Access Compliance Report

Public Rights-of-Way

(Curb Ramps)

Intersection ID: 13094	Main Street: WINNIFRED_ST	Cross Street: WILCOX_ST	Location: S
ADA ID: BACE4B72AA4D	Ramp Type: PerpDiag	Initial Pass/Fail: Fail	Overall Compliance: No
		Severity Score: 37.5

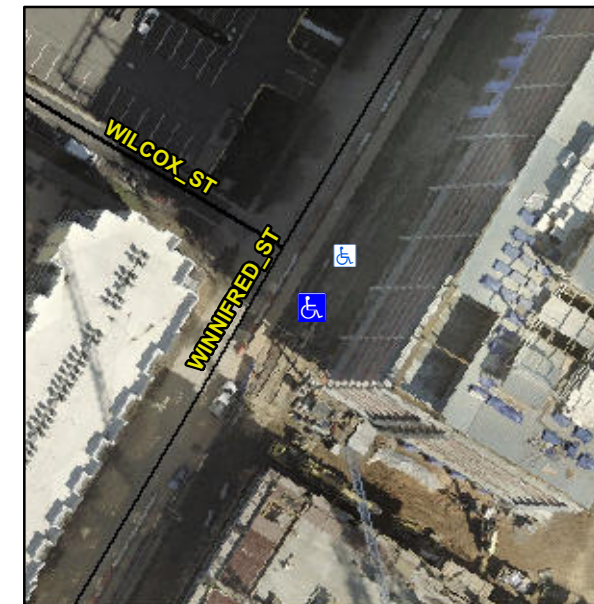
R304.2.2, R304.5.3

Compliance	Description	Data	Compliance	Description	Data
N/A	Ramp Length (in)	58.0	No	Ramp Slope (%)	9.1
Yes	Ramp Width (in)	48.0	No	Ramp XSlope (%)	13.6
N/A	Flare Type LT	N/A	N/A	Flare Type RT	N/A
N/A	Flare Slope LT (%)	N/A	N/A	Flare Slope RT (%)	N/A
N/A	Flare Traversable LT?	N/A	N/A	Flare Traversable RT?	N/A
N/A	Landing Length (in)	N/A	N/A	DWS Provided?	N/A
N/A	Landing Width (in)	N/A	N/A	DWS Contrast?	N/A
N/A	Landing Slope (%)	N/A	N/A	DWS Length (in)	N/A
N/A	Landing X Slope (%)	N/A	N/A	DWS Full Width?	N/A
N/A	Landing Curb? (Y/N)	N/A	N/A	DWS Offset (in)	N/A
N/A	Shared Landing?	N/A			
N/A	Gutter Ponding?	N/A	N/A	Gutter Slope (%)	N/A
N/A	Gutter Lip Ht (in)	N/A	N/A	Gutter X Slope (%)	N/A
N/A	Painted X Walk1?	No	N/A	Painted X Walk2?	No
	X Walk 1 Direction	To NE		X Walk 2 Direction	To NW
N/A	X Walk 1 Width (in)	N/A	N/A	X Walk 2 Width (in)	N/A
	X Walk 1 Slope (%)	0.5		X Walk 2 Slope (%)	2.7
	X Walk 1 X Slope (%)	2.5		X Walk 2 X Slope (%)	0.4

Remove & Replace Curb Ramp With Two New Directional Ramps or Equivalent.
